Access Compliance Report Public Rights-of-Way (Curb Ramps)

Main Street: ACECA_DR Cross Street: SILVER_FOX_RD Location: NW

ADA ID: RPAT211202145023 Ramp Type: Type 1 - Perpendicular Diagonal Initial Pass/Fail: Fail Overall Compliance: No Severity Score: 16

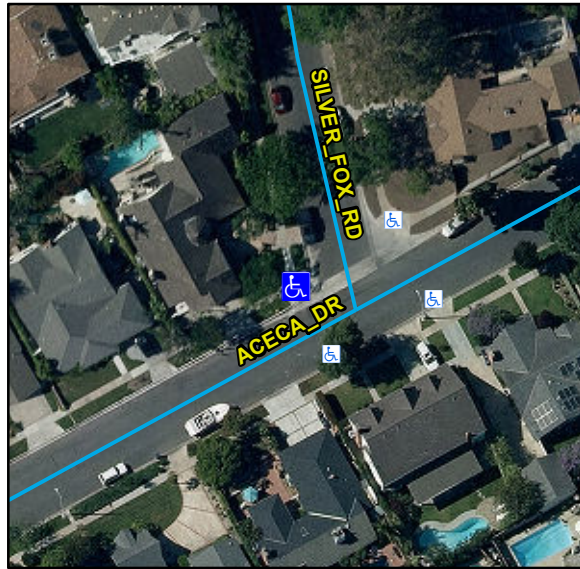
Compliance	Description	Data	Compliance	Description	Data
N/A	Ramp Length (in)	88	N/A	Flare Type LT	
Yes	Ramp Width (in)	50			N/A
No	Ramp Run Slope (%)	9	N/A	Flare Slope LT (%)	N/A
Yes	Ramp Cross Slope (%)	1.4	N/A	Flare Traversable LT	N/A
N/A	Landing Present	N/A	N/A	Flare Type RT	
N/A	Landing Length (in)	N/A			N/A
N/A	Landing Width (in)	N/A	N/A	Flare Slope RT (%)	N/A
N/A	Landing Run Slope (%)	N/A	N/A	Flare Traversable RT	N/A
N/A	Landing Cross Slope (%)	N/A	N/A	DWS Provided	N/A
N/A	Landing Movement Obstructed?	N/A	N/A	DWS Contrast	N/A
	Landing Movement Type	N/A	N/A	DWS Length (in)	N/A
N/A	Landing Shared	N/A	N/A	DWS Full Width	N/A
N/A	Clear Space	Yes	N/A	DWS Offset Left (in)	N/A
N/A	Clear Space To Crosswalk (in)	N/A	N/A	DWS Offset Right (in)	N/A
N/A	Marked Crosswalk 1	No	N/A	Marked Crosswalk 2	No
	Crossing 1 Direction	S		Crossing 2 Direction	E
	Marked Crosswalk 1 Width (in)	N/A		Marked Crosswalk 2 Width (in)	N/A

Remove & Replace Curb Ramp With Two New Directional Ramps or Equivalent.
